UNITED STATES PATENT AND TRADEMARK OFFICE

APPLICATION NO.	FILING DATE	FIRST NAMED INVENTOR	ATTORNEY DOCKET NO.	CONFIRMATION NO.
10/673,510	09/30/2003	Noriaki Okazawa	Q77770	1658
23373	7590	12/08/2006	EXAMINER	
SUGHRUE MION, PLLC 2100 PENNSYLVANIA AVENUE, N.W. SUITE 800 WASHINGTON, DC 20037			FIDLER, SHELBY LEE	
			ART UNIT	PAPER NUMBER
			2861

Office Action Summary	Application No.	Applicant(s)	
	10/673,510	OKAZAWA ET AL.	
	Examiner	Art Unit	
	Shelby Fidler	2861

DETAILED ACTION

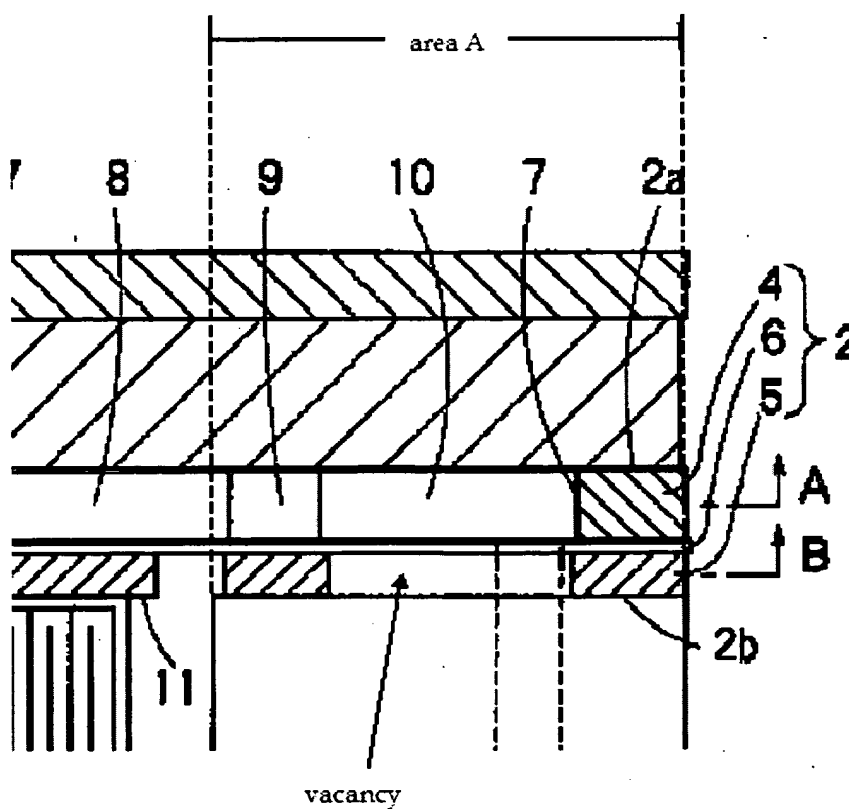
Examiner notes that a clarification of the claimed "area of the flow passage formation section corresponding to both the liquid supply passage partition wall parts and the liquid supply passage of the flow passage formation section" would obviate a reasonably broad

reading of the Kitahara reference. However, the amended claims do not narrow the abovementioned area.

For further clarification, please see the diagram below, which is a clarification of the area in question relating to Drawing 1 of the Kitahara reference. Please note that the area in question (marked as area A) is shown to correspond to both the liquid supply passage partition wall parts (the portion of 7 that relates to element 9; for additional clarity, please also see Fig. 2 of the Kitahara reference) and the liquid supply passage (9) since those elements fall within the range of area A. Also shown is a vacancy that separates the head case section (3) from the first part (6) of the sealing section at the area.
